HIGHCASTLE HOMES

RIVERWALK, PHASE 2
BRAMPTON, ON

SITE PLAN

SITE PLAN REVIEW

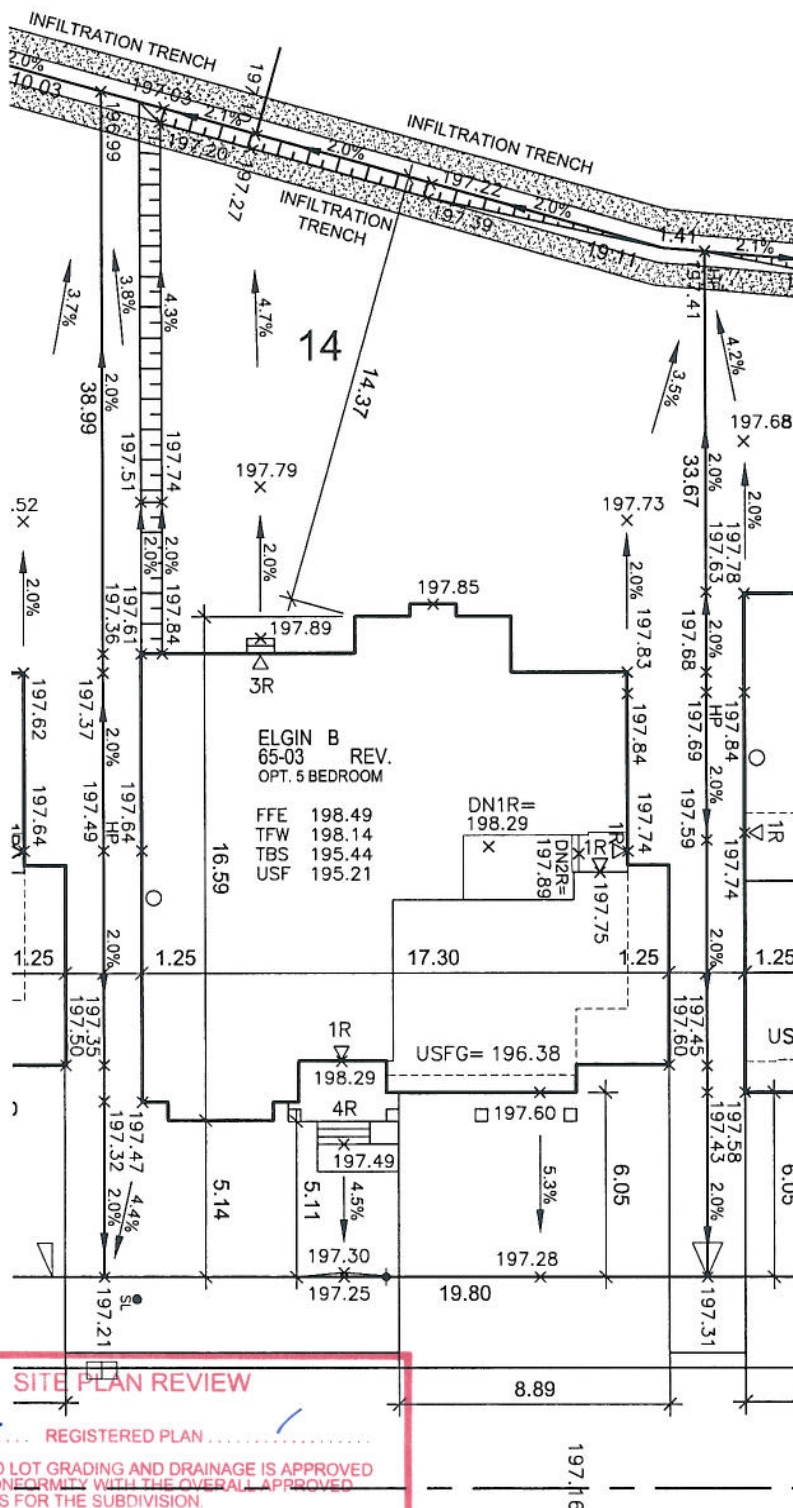
THE PROPOSED LOT GRADING AND DRAINAGE IS APPROVED
AS BEING IN CONFORMITY WITH THE OVERALL APPROVED
GRADING PLANS FOR THE SUBDIVISION.

NOTE:
RLCB LEAD PRESENT, CAUTION WHEN EXCAVATING.
BUILDER TO VERIFY ADEQUACY OF FOUNDING SOILS
ADJACENT TO RLCB LEADS.

SANITARY AND STORM INVERTS ARE NOT AVAILABLE AT THE TIME OF SITING; BUILDER TO VERIFY ELEVATIONS OF SANITARY AND STORM LATERALS IN RELATION TO BASEMENT USF ELEVATIONS FOR COMPLIANCE WITH MUNICIPAL STANDARDS PRIOR TO EXCAVATION.
